NEW FLYER

SERVICE MANUAL BULLETIN

SMB-121C

ISSUE DATE: Feb 19 2015

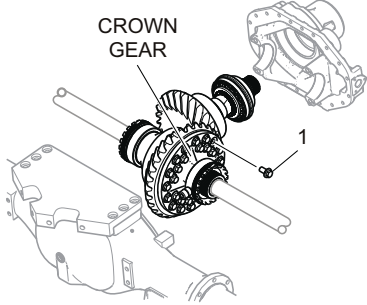
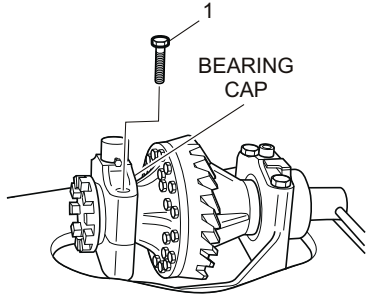
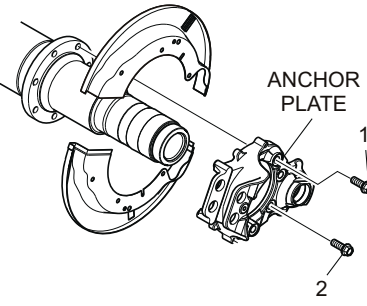
REV B DETAILS	<p>SMB121 dated Dec 19 2012 has been revised to:</p> <ul style="list-style-type: none"><input type="checkbox"/> Correct information provided for the Front Axle, VOK-07 center link and tie rod end fasteners.<input type="checkbox"/> Add information for the Rear Axles, HY-1336 & HY-1350 caliper carrier fastener replacement.<input type="checkbox"/> Add information for the Rear Axles, HY-1350 axle shaft bolt replacement.<input type="checkbox"/> Add information for the Rear Axles, HY-1336 & HY-1350 caliper carrier bolt torquing procedure.				
REV C DETAILS	<p>SMB121 dated May 14 2013 has been revised to:</p> <ul style="list-style-type: none"><input type="checkbox"/> Revised information for the Rear Axles, HY-1336 & HY-1350 caliper carrier bolt torquing procedure not to exceed 130°

Front Axle VOK-07		
Illustration	Description	Procedure
	<p>Center Link & Tie Rod Ends Installation</p> <p>Item 1 - Self-Locking Nut</p>	<p>Discard and replace Item 1 with new. Torque to 221 ft-lb. (300 Nm).</p>
Rear Axle HY-1336		
Illustration	Description	Procedure
	<p>Axle Shaft Installation</p> <p>Item 1 - Hex Head Bolt</p>	<p>Discard and replace Item 1 with new. Torque to 266 ft-lb. (360 Nm).</p>
	<p>Input Flange Installation</p> <p>Item 1 - 12-Point Nut</p>	<p>Discard and replace Item 1 with new. Torque to 701 ft-lb. (950 Nm).</p>
